STATE OF MAINE  
DEPARTMENT OF ENVIRONMENTAL PROTECTION

Re: Sites 1, 3 & Eastern Plume-Monitoring Event 26  
Naval Air Station, Brunswick, Maine

The Maine Department of Environmental Protection (MEDEP) has reviewed the draft "Sites 1, 3 & Eastern Plume, Monitoring Event 26 Report", dated April 2005, prepared by Environmental Chemical Corporation. Based on that review MEDEP has the following comments and issues.

Figure presented at April 2006 Technical Meeting: See comment 7 bullet 4.

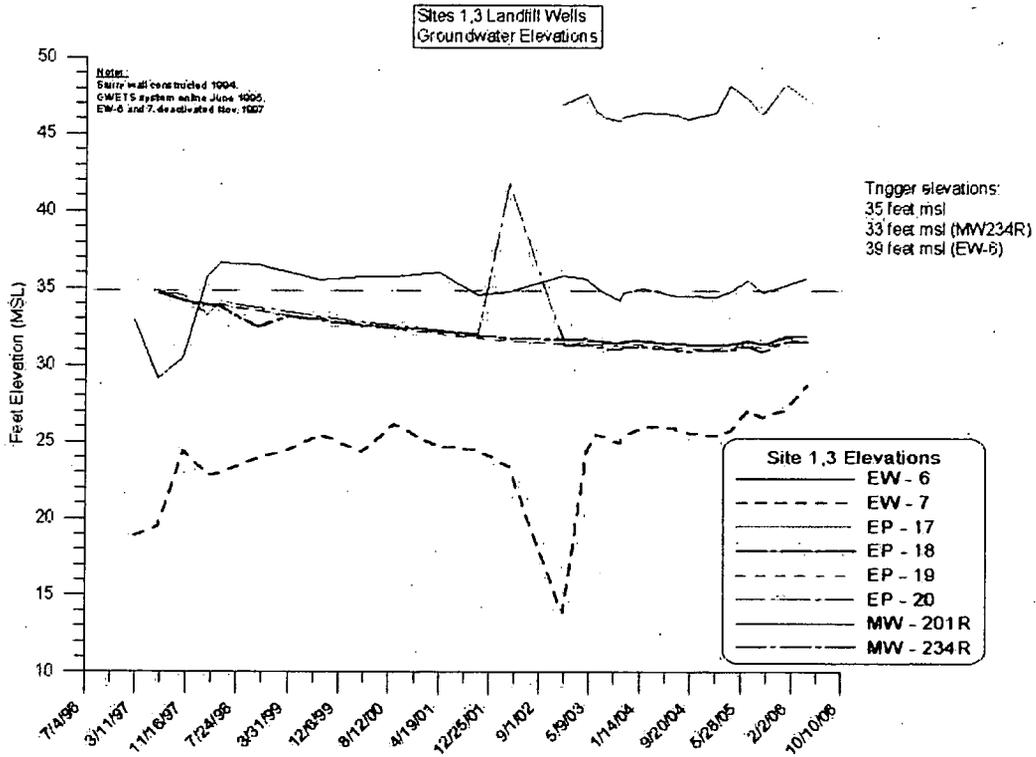
- The water elevation data for the area inside the slurry wall suggest that elevations are slowly increasing. None of the water levels are at the trigger elevations currently, but if this trend continues stakeholders will need to address keeping the water table below the landfill waste. MEDEP presented a figure (attached) depicting the long-term trends at the April 2006 Technical Meeting, and the issue has been discussed by the group.
